Technical Note

Project No: ITB16481
Project Title: Land South of Summer Lane and West of Pagham Road, Pagham
Title: Highways Technical Note
Ref: TW/PL/ITB16481-004a
Date: 8 September 2022

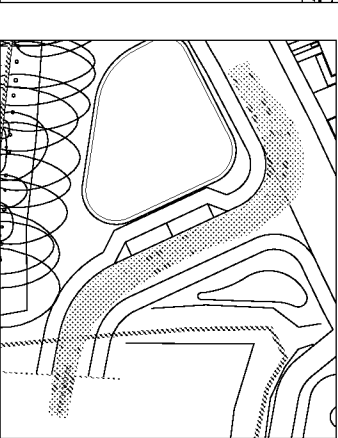
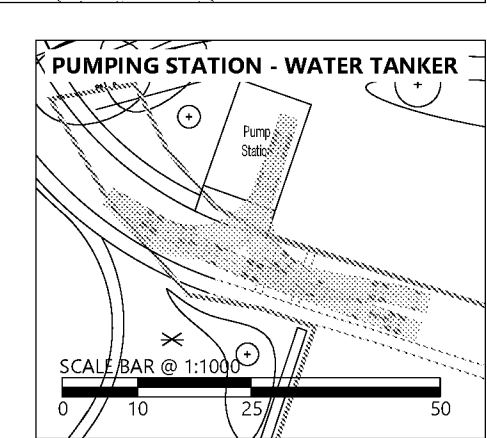
2.2.2 In finalising the layout changes and responding to drainage and landscaping comments received from ADC, a series of minor alterations to the western side of the southern parcel were proposed.

- Reduce a short section of the secondary street (Plots 184-195) to 4.8m (from 5.0m). The Design Code for Secondary Streets identifies a road width of 5.0m – 6.1m with footway. A 4.8m road (with footway) would marginally conflict therefore, but in view of MfS guidance and the limited use expected, this is safe and acceptable.
- Remove the central PROW connection (the connections south and north remain) and associated raised table. This has no material impact on permeability and movement.
- Relocate two visitor bays at Plot 186 to the corner of 184 (a distance of some 20m). Visitor parking spaces remain well spaced across the scheme.
- Minor amendments to the lay-by provision at 245/246.

2.2.3 WSCC confirmed that these amendments were acceptable in transport terms (**Appendix D**). WSCC also confirmed that a margin of at least 0.5m between the road edge and proposed hedge would be required if the road is to be adopted. This margin has been included in the finalised scheme.

POTENTIAL PEDESTRIAN / CYCLIST ACCESS ARRANGEMENTS

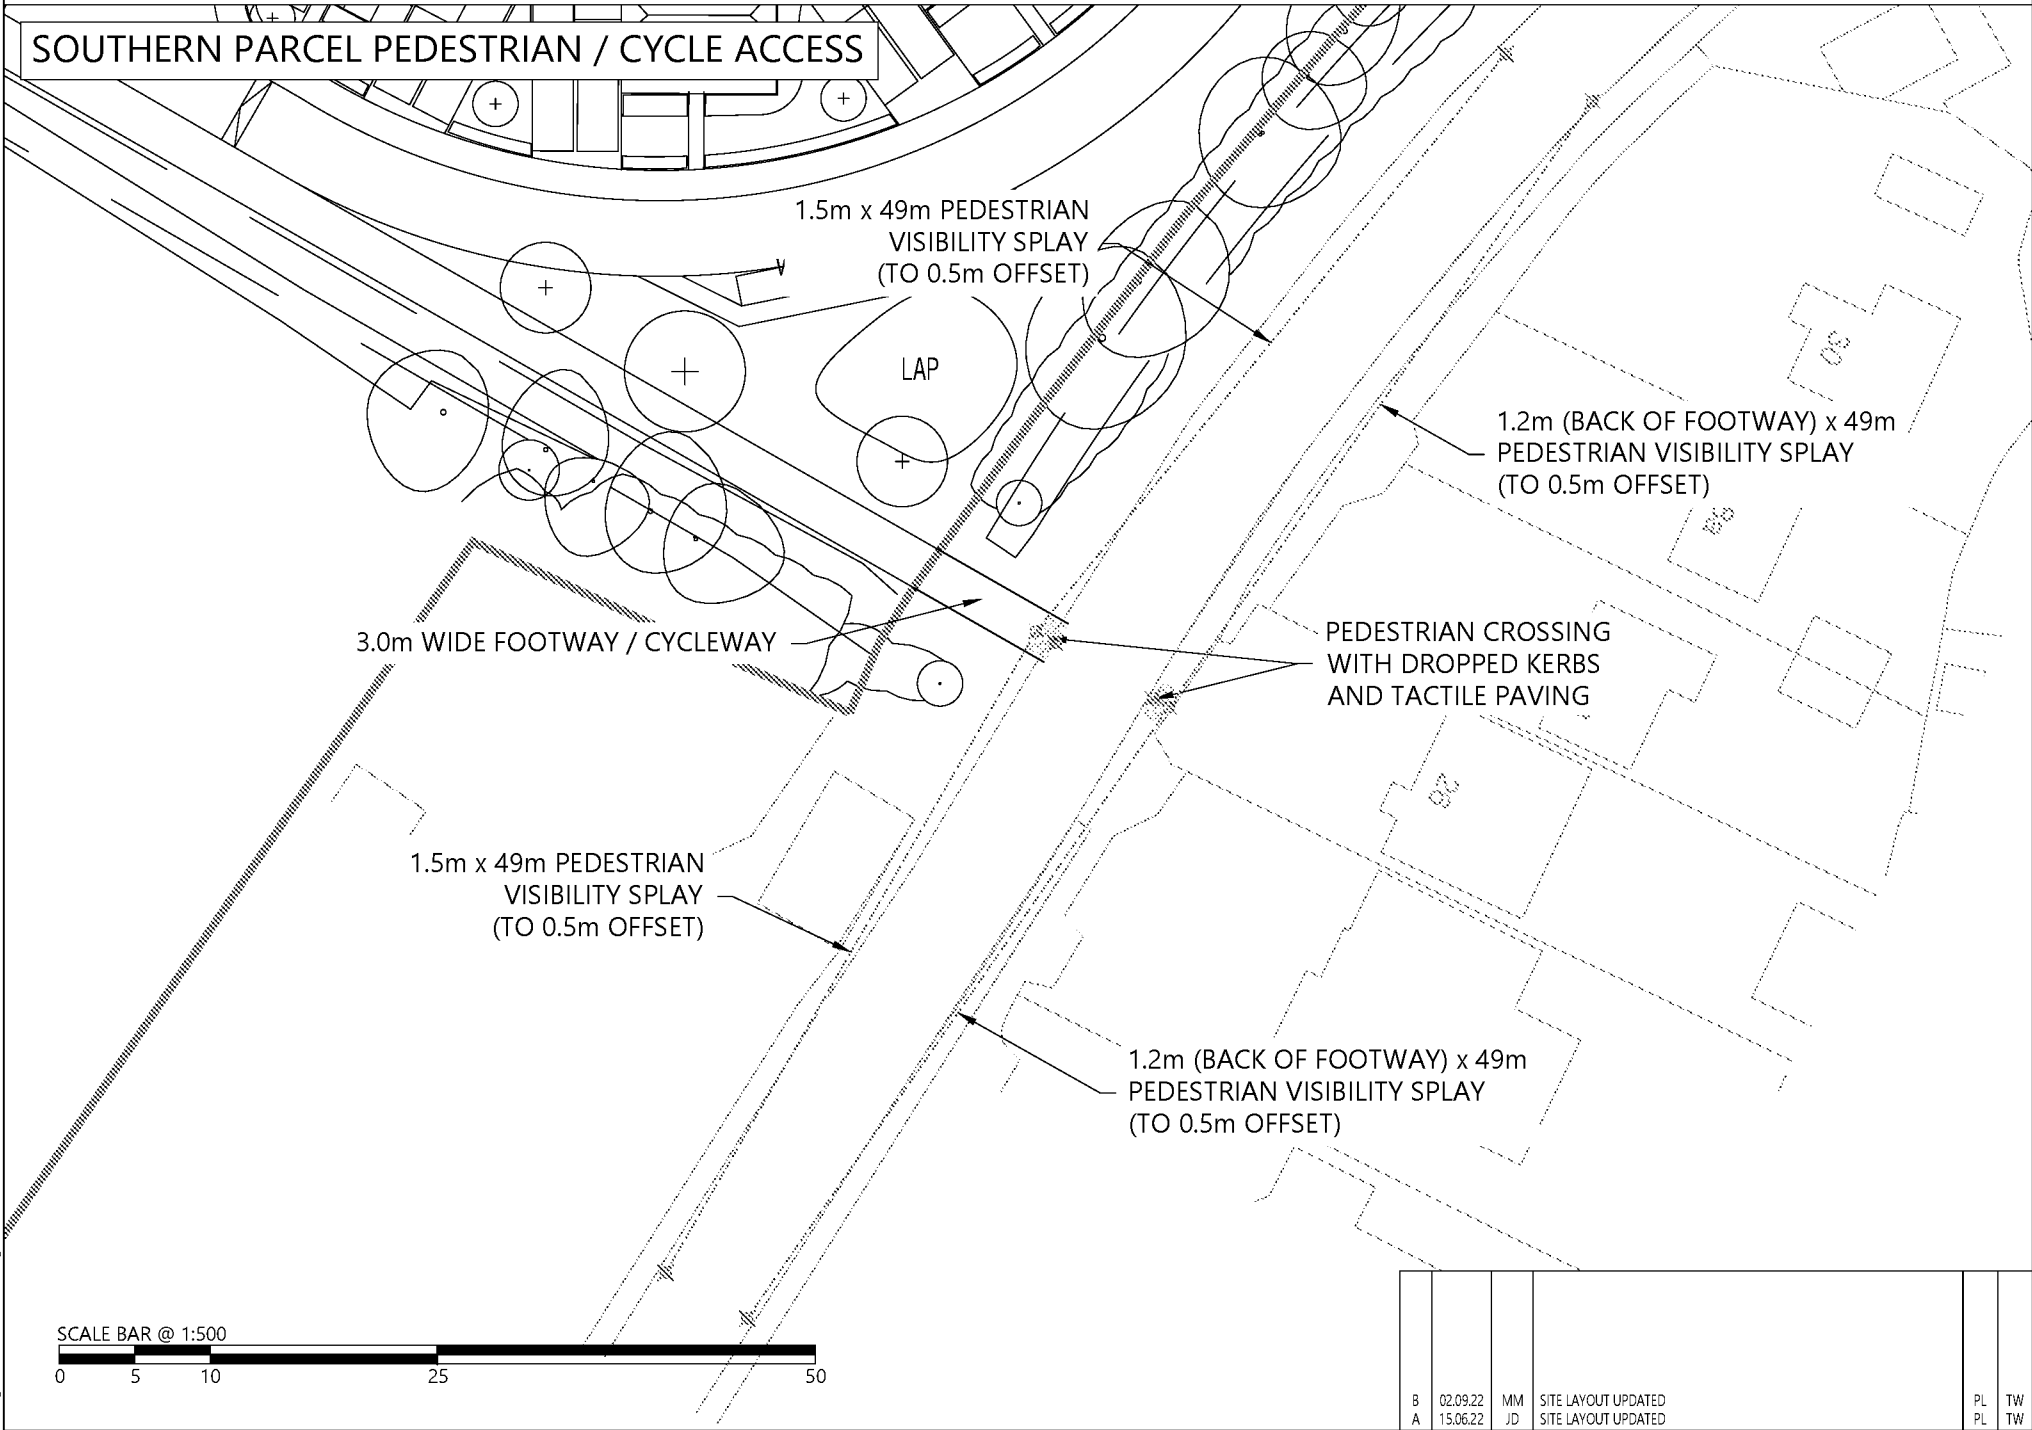
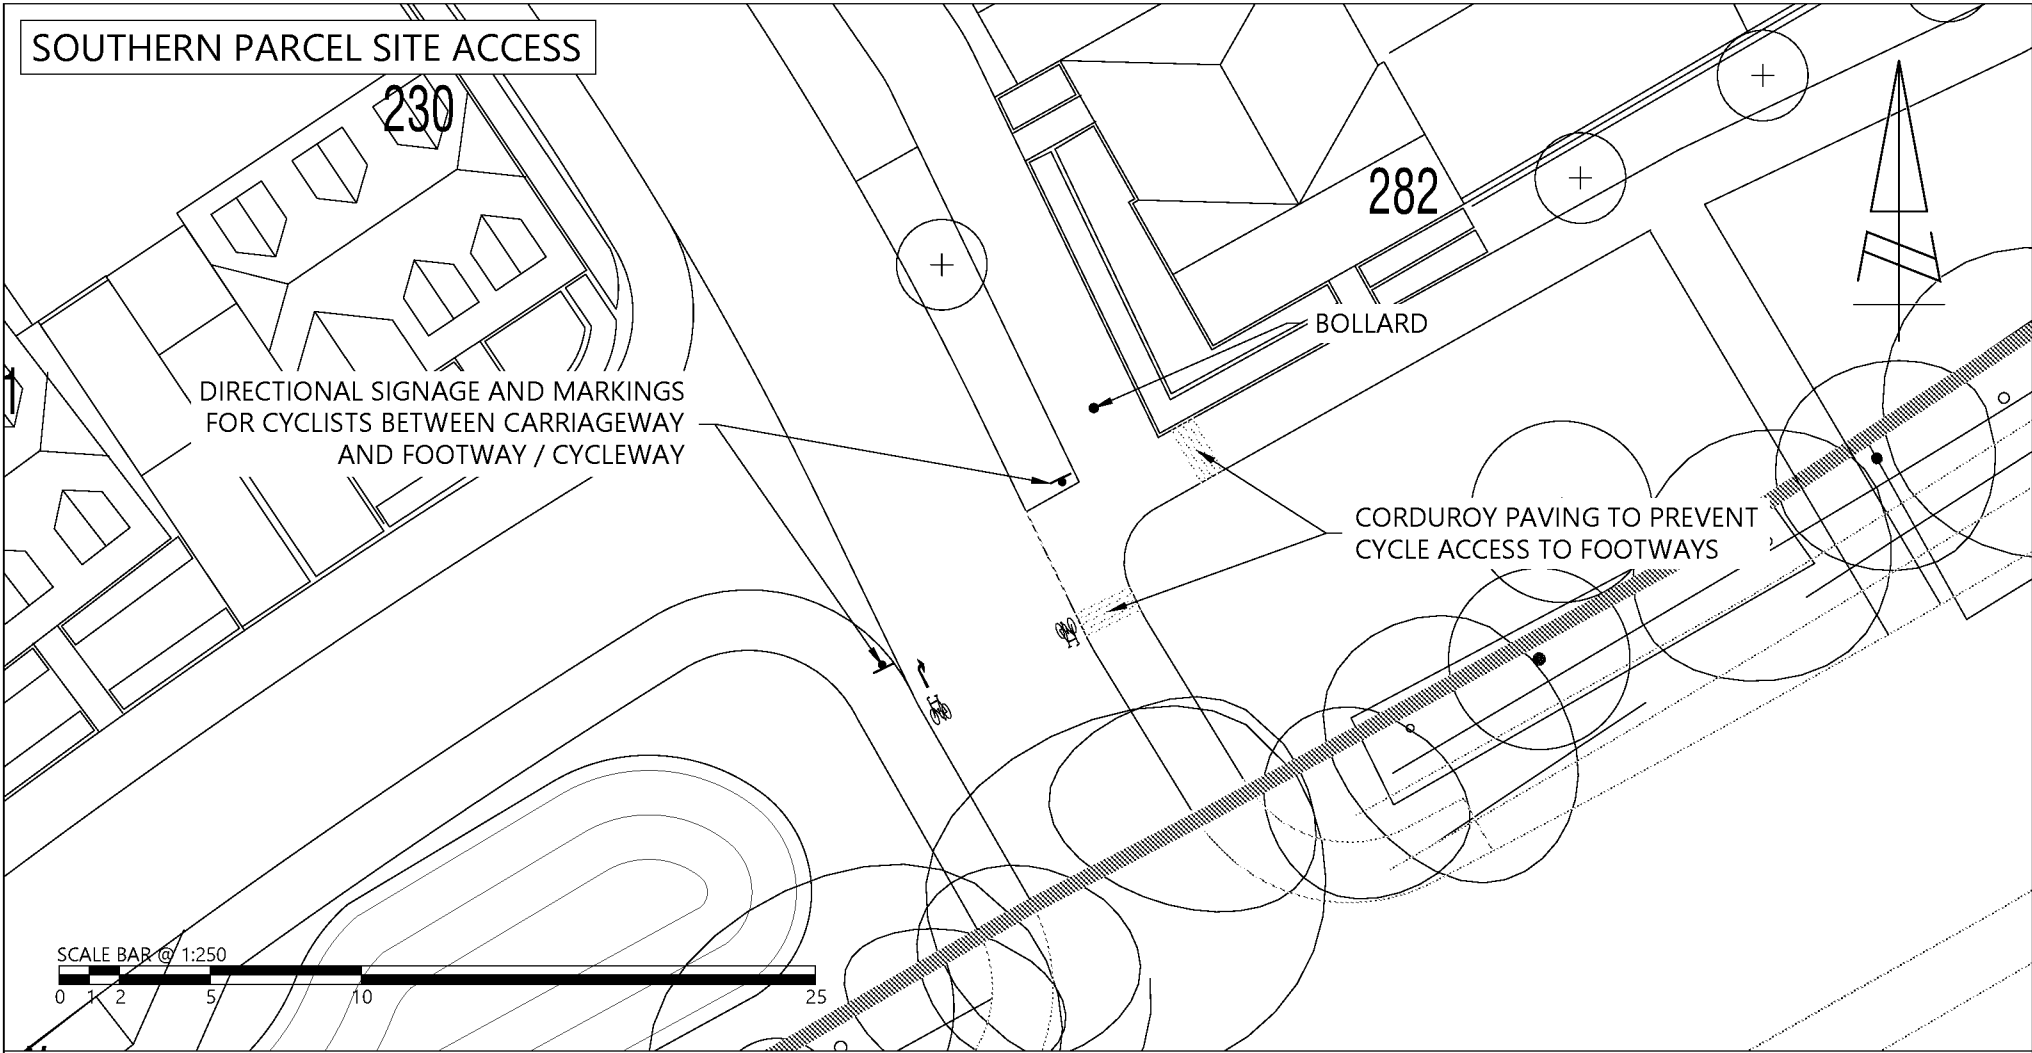
12. The need of for the new southern pedestrian access is perhaps questionable. The applicant would also need to consider and provide further pedestrian crossing infrastructure.	12. The connection at plot 344 was part of the Outline permission and provides a direct access to the bus stop. The southern connection is new, but WSCC has since then confirmed no objections in principle to this being created, which will improve permeability. Crossing facilities would comprise a dropped kerb and tactile paving as illustrated in Drawing ITB16481-GA-007 .
